CLARIFICATIONS No. 4

Procurement related to:

CONSTRUCTION OF THE NEW ELEMENTARY SCHOOL “CITY KVART” PODGORICA, MONTENEGRO

ICB No: 01-908/26-788/1 published on 11 March 2026

Detail of Antenna pole

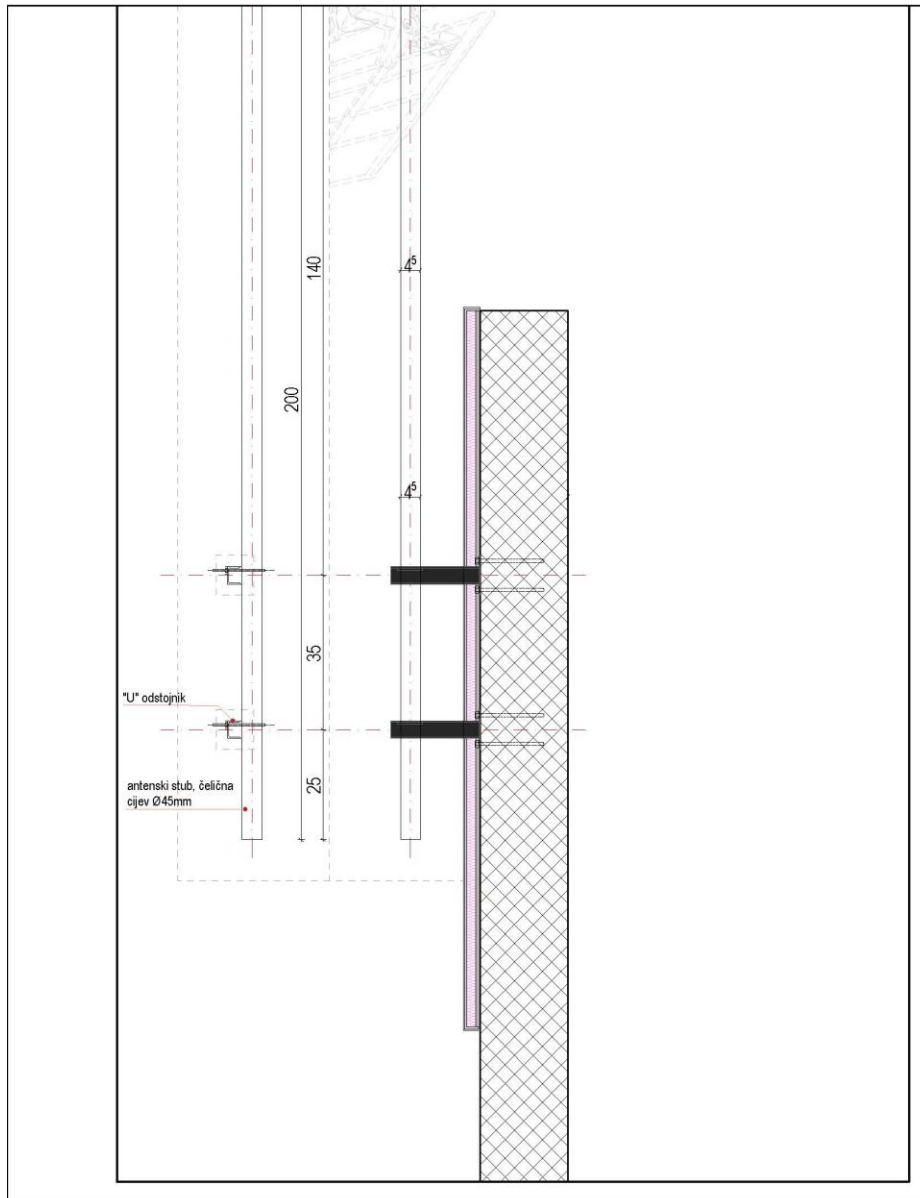
Please provide a drawing of antenna pole.

Technical sheet of Antenna pole
